# **Technical Updates for Pool Professionals**

### June/2020

## **Changes to UHS Heaters 06/2020**

# **Changes to UHS Heaters 06/2020**

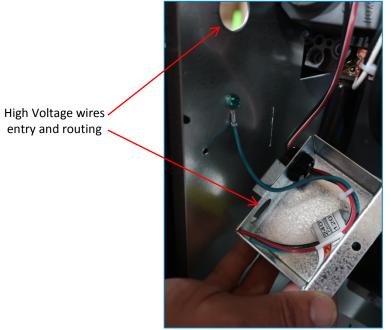
Beginning June 1 2020 all UHS heaters will be built with the following changes

- High and low voltage wiring terminal blocks have been eliminated
- Wiring connections will be made with wire nuts that are included with heater
- High voltage wiring will be in a junction block that comes from the factory on the left side of the heater, but that is convertible to the right side.
- Low voltage (automation) wiring harness will come in the vinyl pouch along with the wire nuts, fuses, low voltage entry grommet, and wiring diagram.
- To connect automation you will plug in the low voltage harness to the ICB and the wires from the automation can enter the heater from either the left or the right side.
- Gas line connections can only be made on the left side of the heater.

When relocating junction box to right side remove high voltage wires from wire retainer clip

High Voltage Junction Box relocated to right side

# **Changes to UHS Heaters 06/2020**

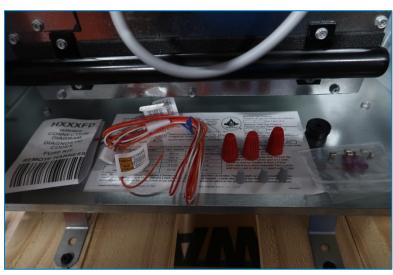
Low voltage wiring connection on ICB

Low voltage wiring entrance grommet installed

Low voltage wire labels

### **HL-Base MSP Update**

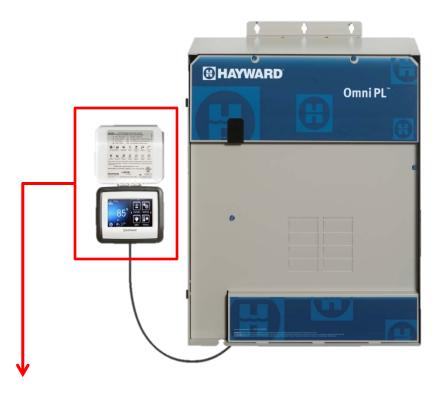
HL-Base MSPs manufactured after May 14, 2020 ship with a new LCD(HLX-LCD0520).

- MSPs manufactured after May 14, 2020 ship with Omni firmware R3.2.2.
- R3.2.2 is similar to R3.2.0, but the new LCD requires firmware R3.2.2 to function.
- MSPs manufactured after May 14, 2020 should never be downgraded to firmware R3.2.0 or lower.
- Firmware R3.2.2 is backwards compatible, and can be installed on all OmniLogic MSPs.
- MSPs manufactured after May 14, 2020 can only use firmware R3.2.2 or higher.

A change has been made to the OmniLogic's (HL-Base) LCD. We have switched to a new manufacture for the LCD in the HL-Base MSP. The part number for the new LCD is **HLX-LCD0520**.

- If the HL-Base was manufactured prior to May 14, 2020 continue to use HLX-LCD for a replacement LCD screen.
- HL-Base manufactured after May 14, 2020 will use the new LCD screen with the part number **HLX-LCD0520**. If a replacement LCD is needed, use only **HLX-LCD0520**.
- HLX-LCD0520 is not backwards compatible with units manufactured prior to May 14,
  2020.
- HLX-LCD cannot be installed in MSPs manufactured after May 14, 2020.
